RE: Application of Homeland/Verizon Wireless ("Applicants" for Special Permit,
Site Plan and Steep Slope Permits and Application for Variances ("Applications")
180 So. Bedford Road, Mt Kisco NY (P/O Tax ID # 80.44-1-1)

RE: Application of Homeland/Verizon for Special Permit,
Site Plan and Steep Slope Permits and Application for Variances
180 So. Bedford Road, Mt. Kisco NY (P/O Tax ID # 80.44-1-1)

1 LANDSCAPING PLAN
LS-1 SCALE : 1" = 20'-0"

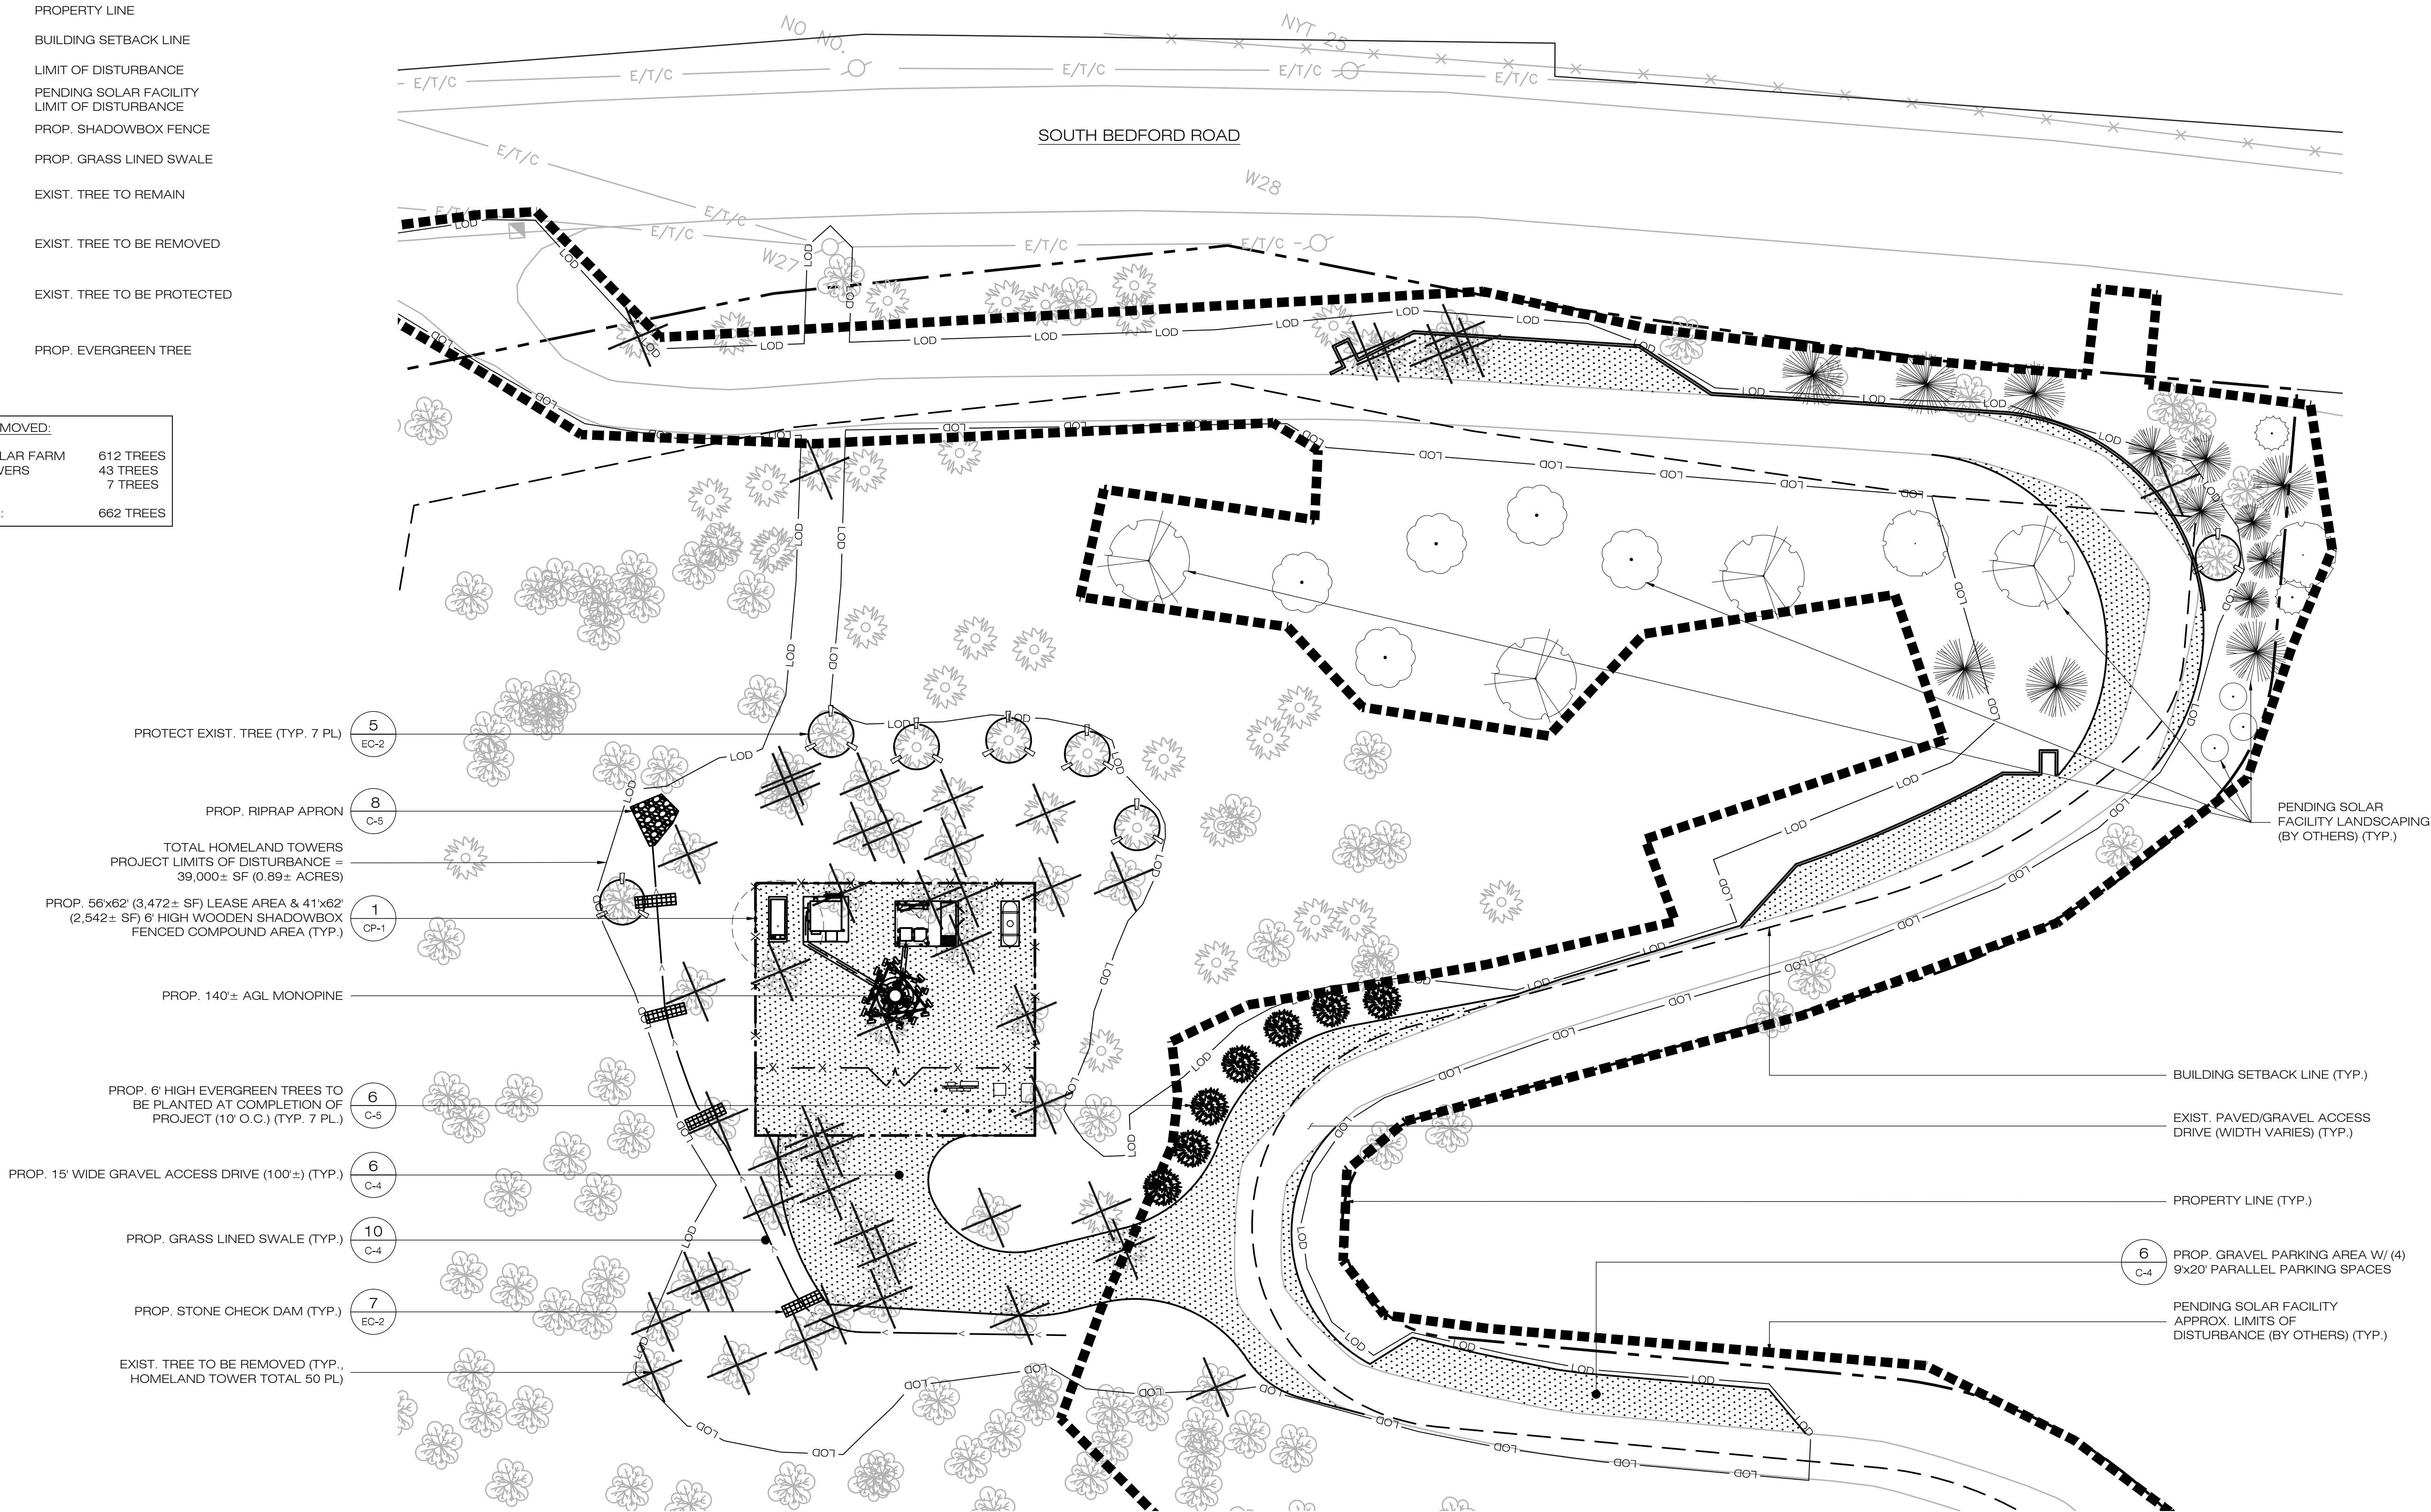
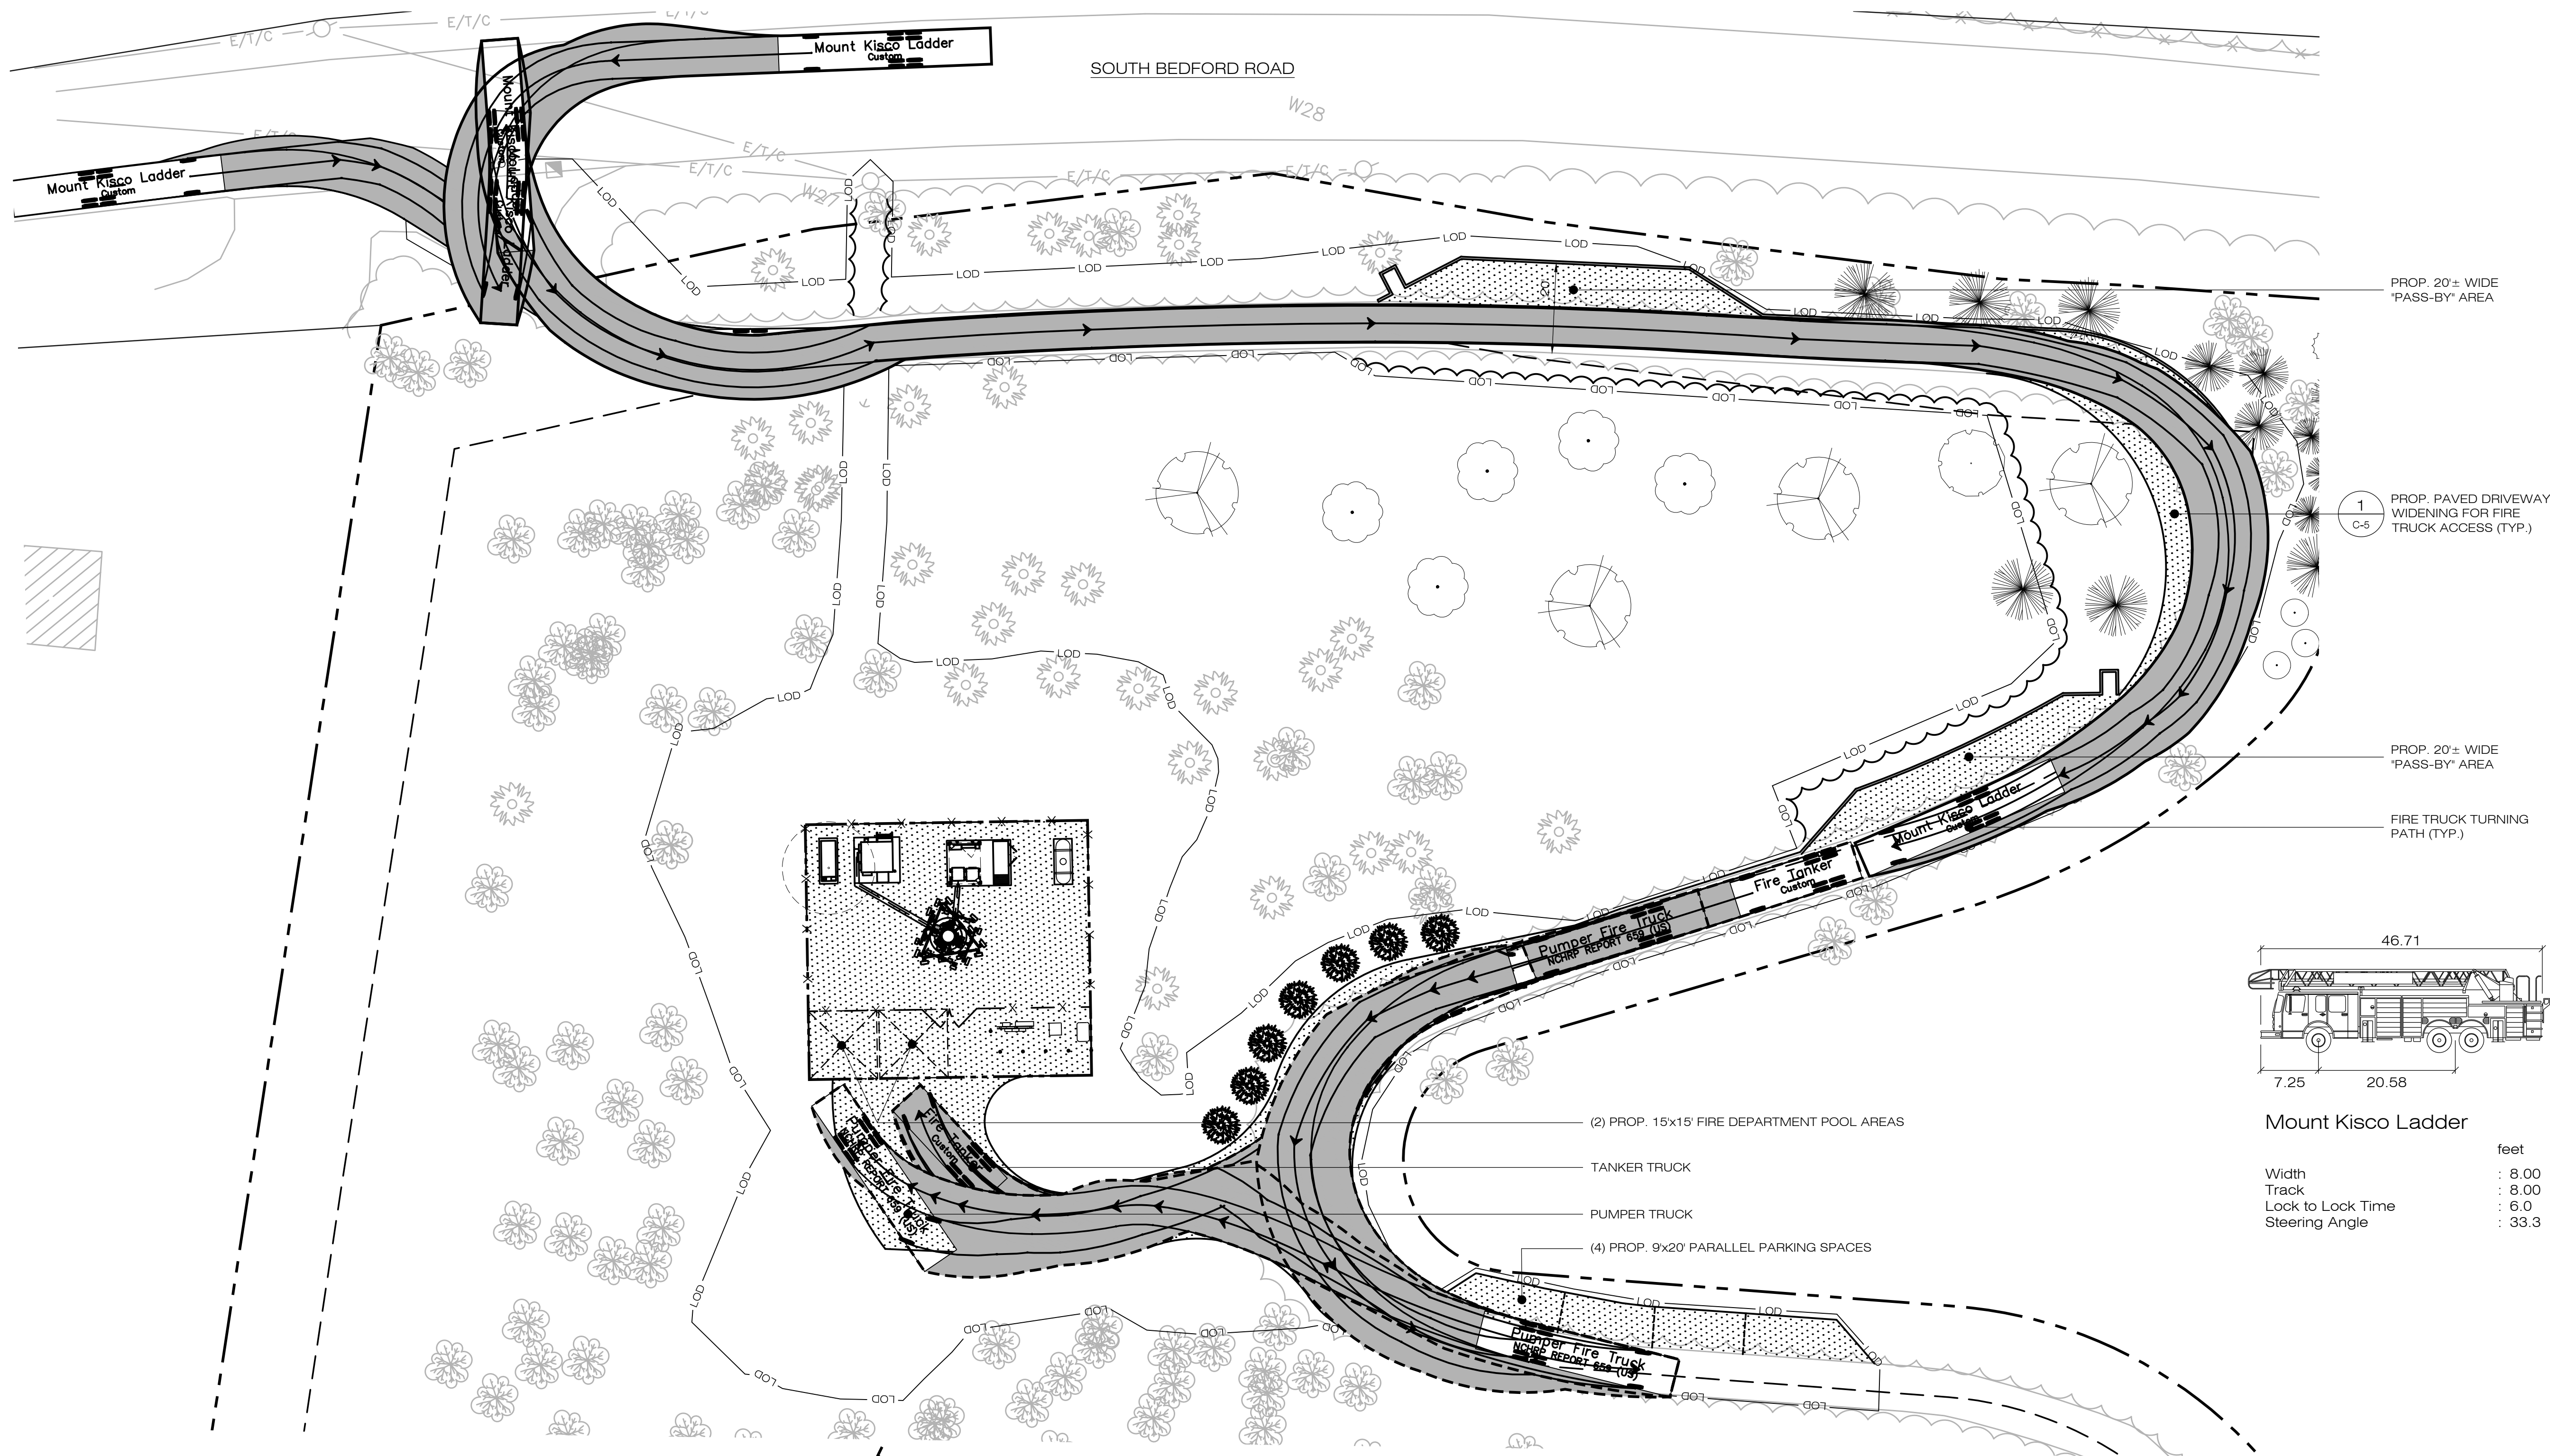
Homeland is cavalierly seeking to carve out additional detached parking spaces outside of its own approximate 4,000 sq ft site within the 25-acre parcel. A plan was ‘innocuously’ submitted by Homeland which creates four (4) 9’x20’ gravel parking spaces right up to our family’s southwestern property line. And, while you will see on LS-1 below that Homeland’s proposal

Homeland's submission proposes its new parking area (violative of the northern buffer) on their Landscaping Plan referenced as "PROP GRAVEL PARKING AREA W/(4) 9'x20' PARRALELL PARKING SPACES"). This proposed off-site parking follows Homeland's contradictory repeated claims of confinement to its small space within the 25-acres, notwithstanding parking spaces being expressly prohibited in buffer zones under the Mount Kisco Code.

Homeland LS-1; Pg 402, 08/10/21 PB Packet, parking masked as a 'pull-over' (emphasis is added.)
